Permanent Extended Detention Basin Certification Letter

Project: Electronic Storage

Site Location: 7717 Electronic Drive, Colorado Springs, CO

As-Built Design Spreadsheet

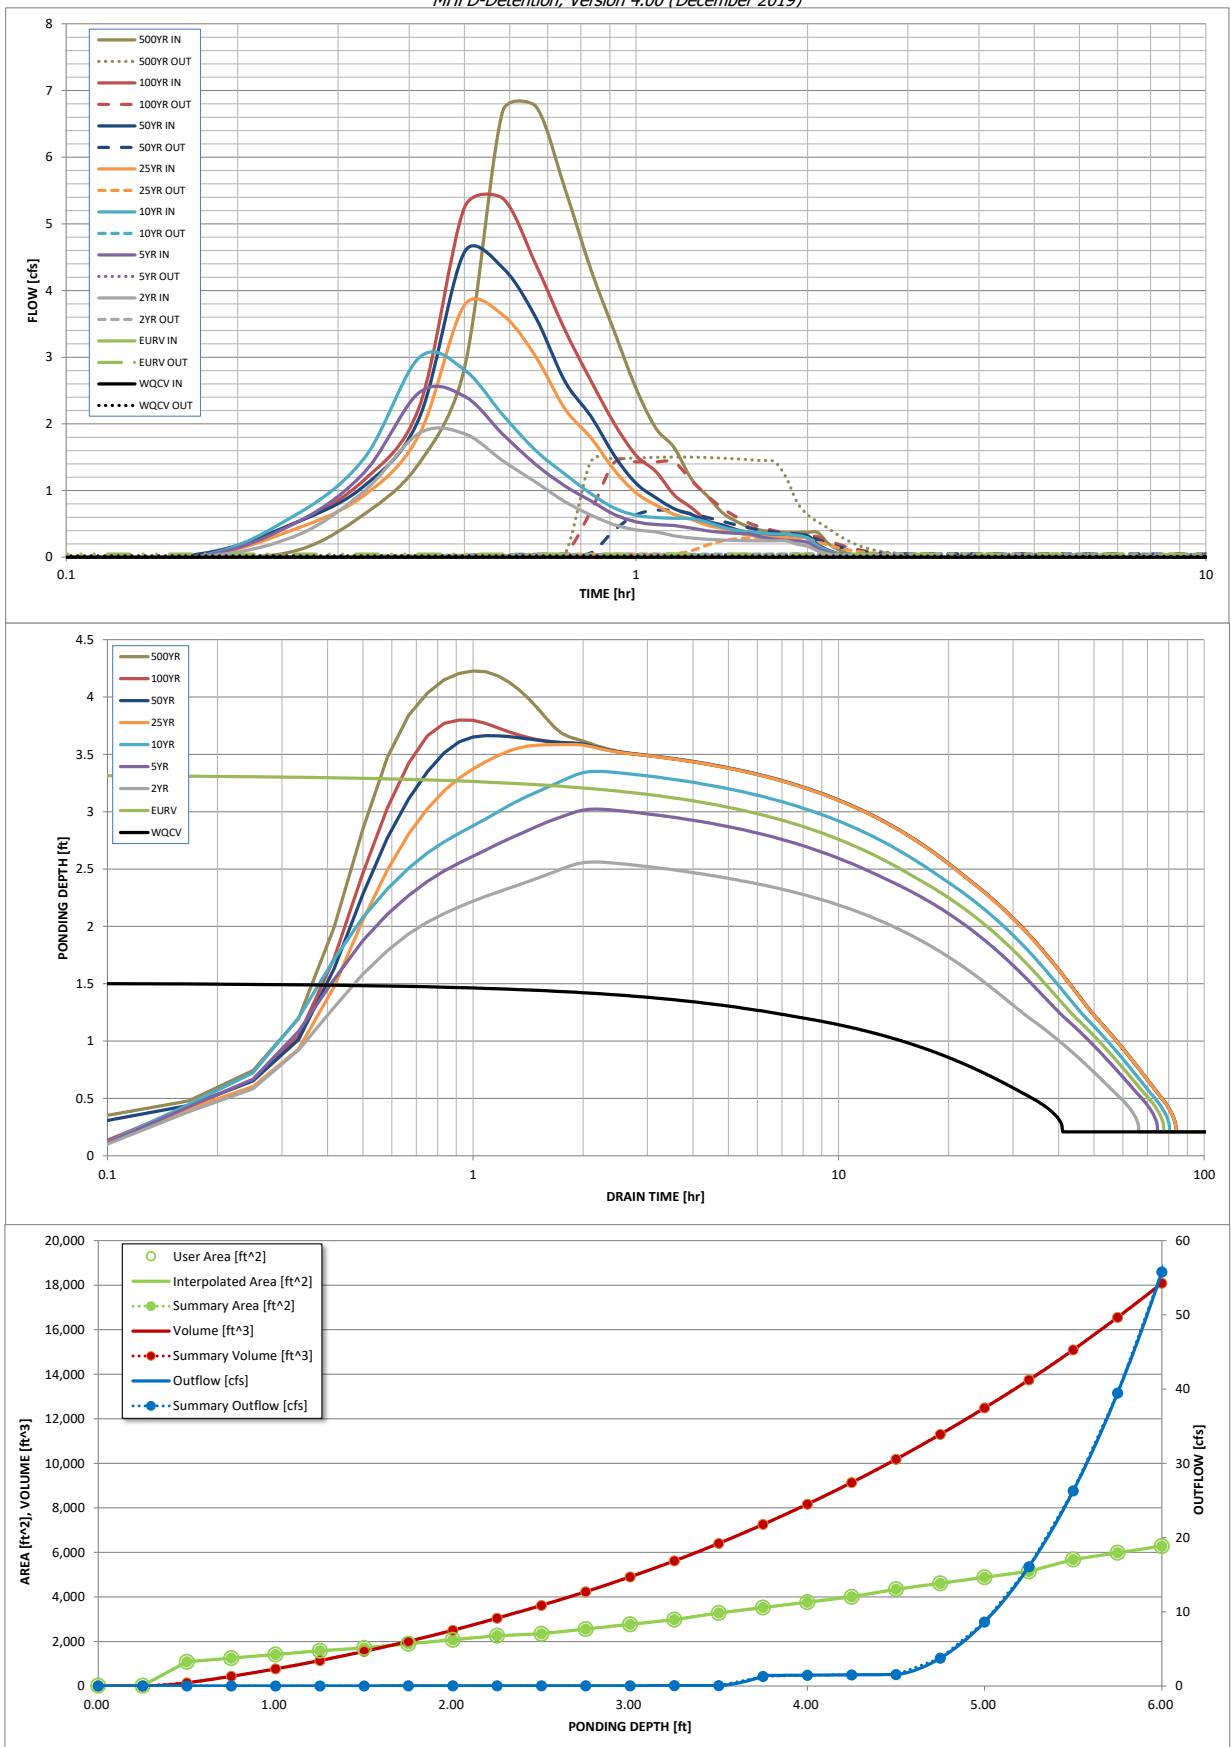
- The top of the outlet structure was constructed 6" high.
 - Per the design spreadsheet the storage volume and flow rates are still acceptable in this condition.

- The inlet orifice plate bottom orifice was constructed 0.2' high. This orifice was then enlarged to adjust flows for the higher elevation.
 - Per the design spreadsheet the storage volume and flow rates are acceptable in this condition.

- The outlet structure top grate installed is different from the plans and has a significantly different open area. The grate installed is heavy cast iron with relatively small openings.

- On the design spreadsheet the grate open area was lowered to 40% to account for this different grate.

Figure 13-12c. Emergency Spillway Protection

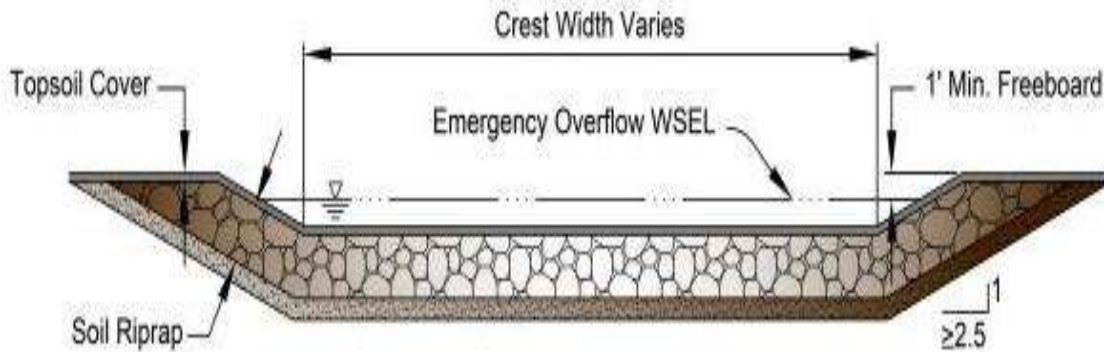
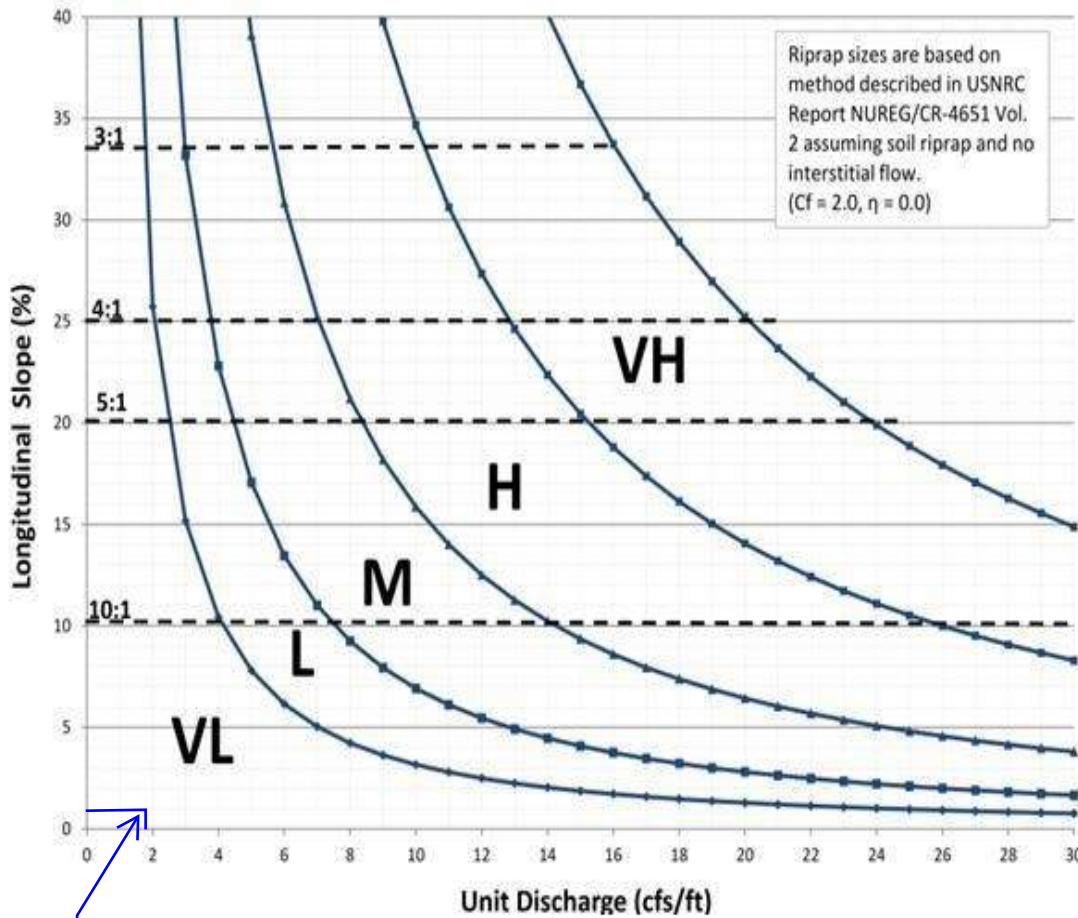
- The path of riprap after the spillway is 3-5' wide with D50=12" riprap set below the surrounding grade. Per the attached spillway riprap sizing chart, 12" is larger than required.

VL riprap required (6")

- 5.4 cfs / 3' wide channel = 1.8
- Channel is nearly flat, assuming 1% slope
